SUNDRY NOTICES AND REPORTS ON WELLS (DO NOT USE THIS FORM FOR PROPOSALS TO DRILL OR TO DEEPEN OR PLUG BACK TO A DIFFERENT RESERVOIR. USE "APPLICATION FOR PERMIT" (FORM C-101) FOR SUCH PROPOSALS.)		WELL API NO. 30-025-01972
1. Type of Well: Oil Well <input checked="" type="checkbox"/> Gas Well <input type="checkbox"/> Other		5. Indicate Type of Lease STATE <input checked="" type="checkbox"/> FEE <input type="checkbox"/>
2. Name of Operator Walsh & Watts Inc		6. State Oil & Gas Lease No. 332461
3. Address of Operator 155 Walsh Drive Aledo, TX 76008		7. Lease Name or Unit Agreement Name STATE 197
4. Well Location Unit Letter P : 330 feet from the S line and 330 feet from the E line Section 6 Township 17S Range 34E NMPM County Lea		8. Well Number #001
11. Elevation (Show whether DR, RKB, RT, GR, etc.) 4118'

Walsh & Watts		CURRENT			
Author:	RP				
Well Name	State 197	Well No.	#1		
Field/Pool	Vacuum Grayburg San Andres	API #:	30-025-01972		
County	Lea	Location:	330 FSL & 330 FEL		
State	NM		Sec6, T17S, R34E		
Spud Date	3/15/1938	GL:	4118

Action 548073

Operator: WALSH & WATTS INC 155 Walsh Drive Aledo, TX 76008	OGRID: 24558
	Action Number: 548073
	Action Type: [C-103] NOI Plug & Aband

Walsh & Watts		PROPOSED	
Author:	RP		
Well Name	State 197	Well No.	#1
	Vacuum		
Field/Pool	Grayburg San	API #:	30-025-01972
	Andres		
County	Lea	Location:	330 FSL & 330 FEL
State	NM		Sec6, T17S, R34E
Spud Date	3/15/1938	GL:	4118

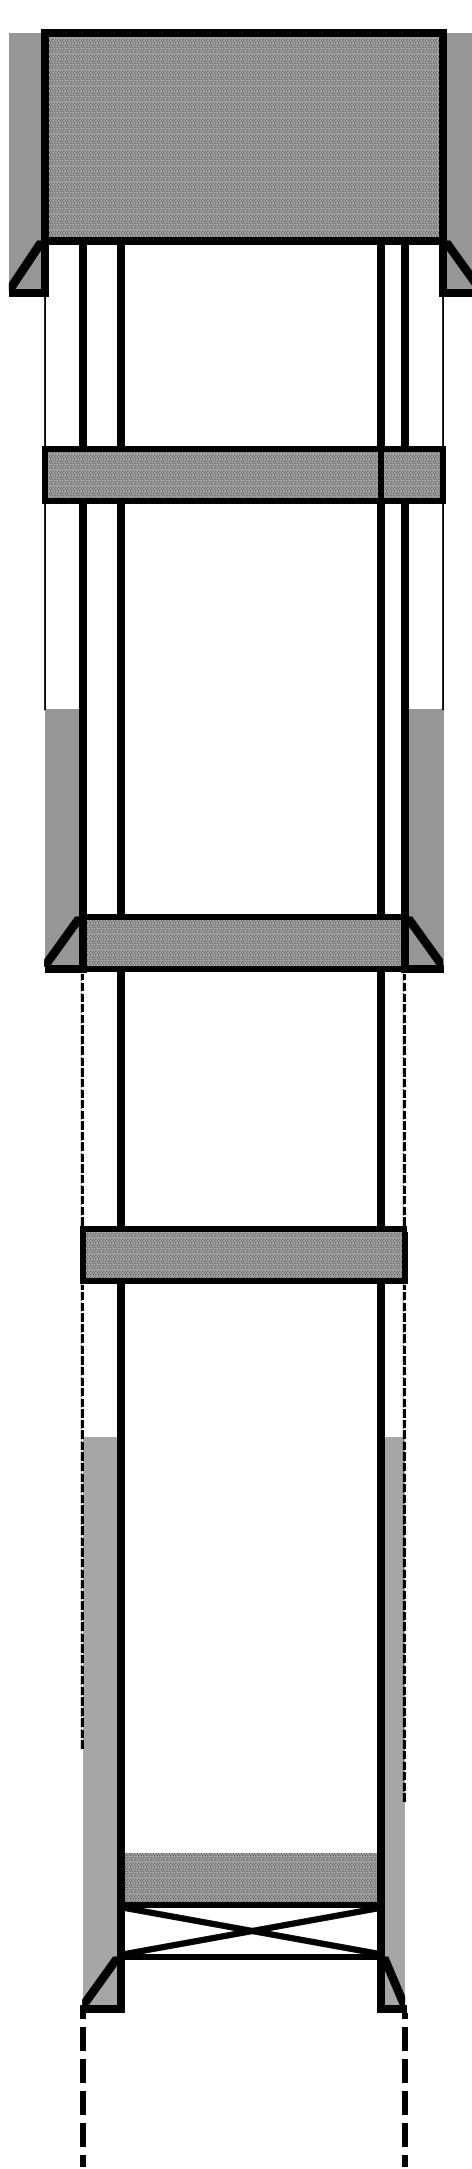
1. Set 7 CIBP @ 4309'. Circ hole w/ MLF. Pressure test csg 500psi/30min - Run CBL to surface - Spot 50 sx cmt @ 4309-4109'.
2. Perf & Sqz 100 sx cmt @ 3850'-3532'. WOC & Tag (T Queen - B/Salt)
3. **Perf & Sqz 100sx cmt @ 3188' - 2988' - WOC & Tag - T 7Rivers**
4. Perf & Sqz 100 sx cmt @ 2865-2656'. WOC & Tag (T Yates & 9 5/8" Shoe)
5. Perf & Sqz 60 sx cmt @1623-1523'. WOC & Tag (T/Salt)
6. Perf & Sqz cmt @ 310' to surface. WOC & Bubble Test
7. Cut off wellhead, verify cmt at surface, weld on Dry Hole Marker.

SEE ATTACHED COA's

Created By	Condition	Condition Date
gcordero	Adhere to current Plug & Abandon (P&A) Conditions Of Approvals (COA).	2/3/2026
gcordero	A Cement Bond Log (CBL) is required to be submitted to electronic permitting.	2/3/2026
gcordero	Submit Cement Bond Logs (CBL) prior to submittal of C-103P.	2/3/2026
